#### **CERTIFICATE OF APPROPRIATENESS**

Property: 915 Columbia St.- Lot 10 Block 227, Houston Heights; 6,600 SF Lot, 1,232 SF 1-story

**Proposal:** 2-story rear addition that begins at the rear of the existing, original 1-story house.

ITEM B4
915 Columbia St
Houston Heights South

01 PROPOSED NORTH ELEVATION OPTION 3

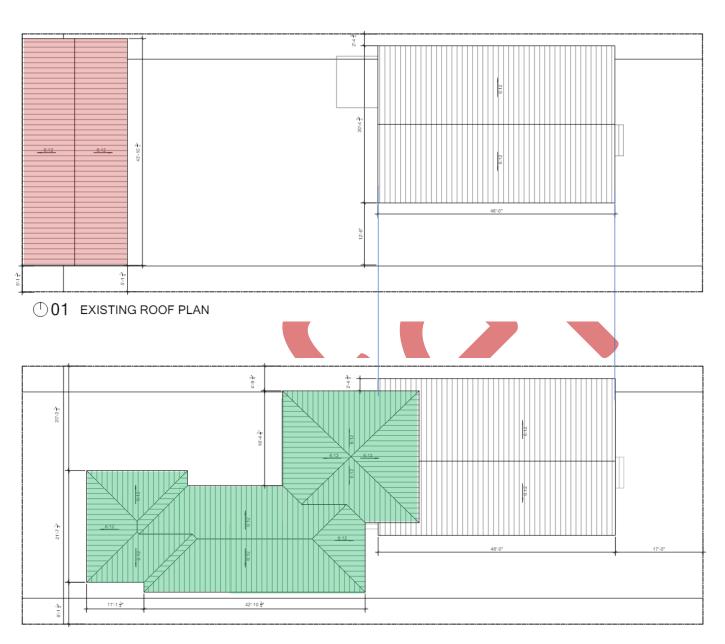
Recommendation: Denial does not meet Heights Design Guidelines, Measurable Standards.
